ARA4 - Replacing the Cell Block Module on High-Voltage Battery (Recall Campaign)

Vehicle Type: **Taycan (Y1A / Y1B / Y1C)**

Concerns: **Cell block module**

**Information****Processing campaign ARA4**

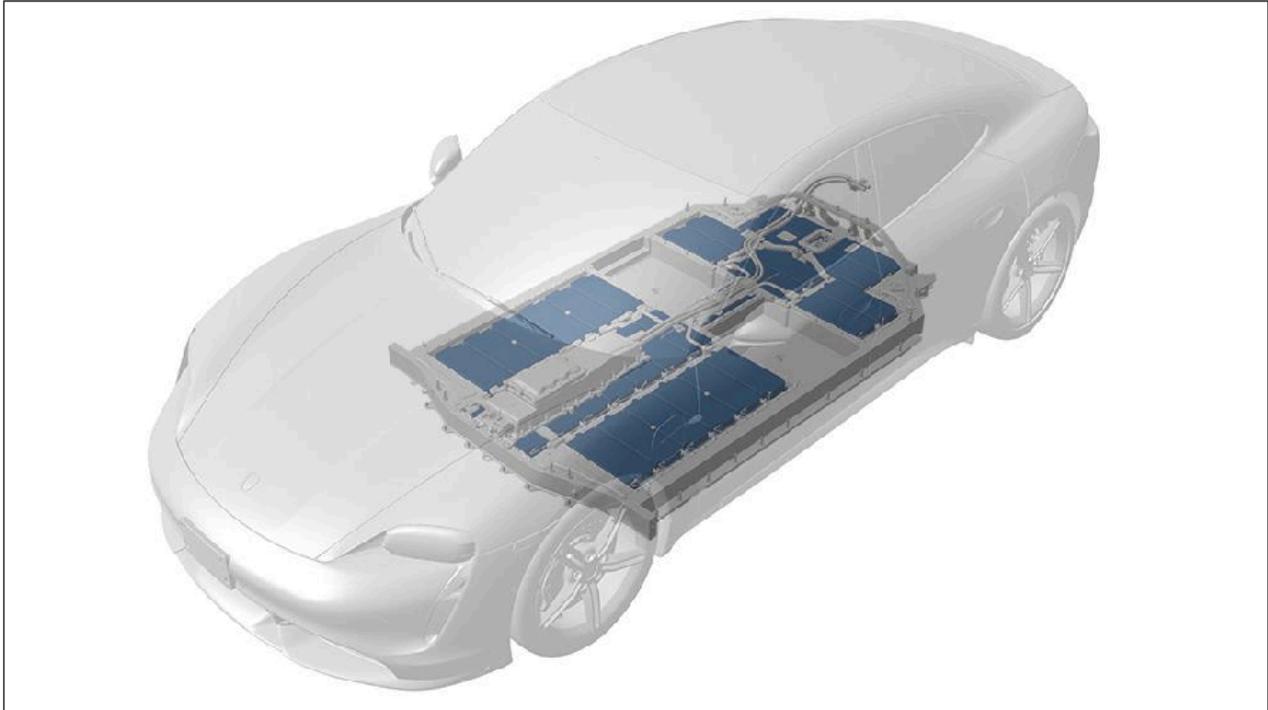
As a procedural safeguard and for control purposes, this action will involve a **two-fold implementation**. This means that administrative **processing and all preparatory activities** are carried out via the **recall campaign ARA4** and the **operational exchange of the cell block module** takes place via the parallelly assigned **accompanying action WRJ5**.
